Access Compliance Report

Public Rights-of-Way

(Curb Ramps)

Intersection ID: 10829	Main Street: E_34TH_ST	Cross Street: HOLT_ST	Location: N
ADA ID: AD50AAC39758	Ramp Type: Perp	Initial Pass/Fail: Fail	Overall Compliance: No
Severity Score: 21.25			
Codes/Mitigation Info/Possible Solution		Field Measurements/Component Compliance

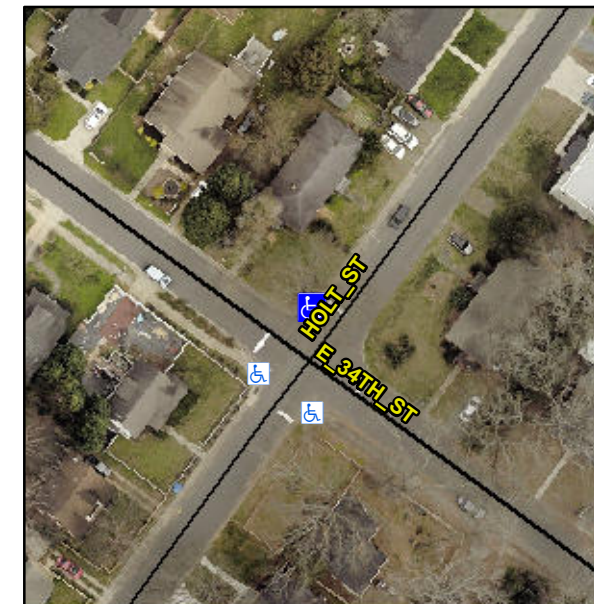
Not Found, R304.5.1, R304.2.2

Compliance	Description	Data	Compliance	Description	Data
N/A	Ramp Length (in)	55.0	No	Ramp Slope (%)	11.2
No	Ramp Width (in)	47.5	Yes	Ramp XSlope (%)	2.0
N/A	Flare Type LT	N/A	N/A	Flare Type RT	N/A
N/A	Flare Slope LT (%)	N/A	N/A	Flare Slope RT (%)	N/A
N/A	Flare Traversable LT?	N/A	N/A	Flare Traversable RT?	N/A
N/A	Landing Length (in)	N/A	N/A	DWS Provided?	N/A
N/A	Landing Width (in)	N/A	N/A	DWS Contrast?	N/A
N/A	Landing Slope (%)	N/A	N/A	DWS Length (in)	N/A
N/A	Landing X Slope (%)	N/A	N/A	DWS Full Width?	N/A
N/A	Landing Curb? (Y/N)	N/A	N/A	DWS Offset (in)	N/A
N/A	Shared Landing?	N/A			
N/A	Gutter Ponding?	N/A	N/A	Gutter Slope (%)	N/A
N/A	Gutter Lip Ht (in)	N/A	N/A	Gutter X Slope (%)	N/A
N/A	Painted X Walk1?	No	N/A	Painted X Walk2?	N/A
	X Walk 1 Direction	To SW		X Walk 2 Direction	N/A
N/A	X Walk 1 Width (in)	N/A	N/A	X Walk 2 Width (in)	N/A
	X Walk 1 Slope (%)	2.1		X Walk 2 Slope (%)	N/A
	X Walk 1 X Slope (%)	2.7		X Walk 2 X Slope (%)	N/A

Remove & Replace Entire Ramp.
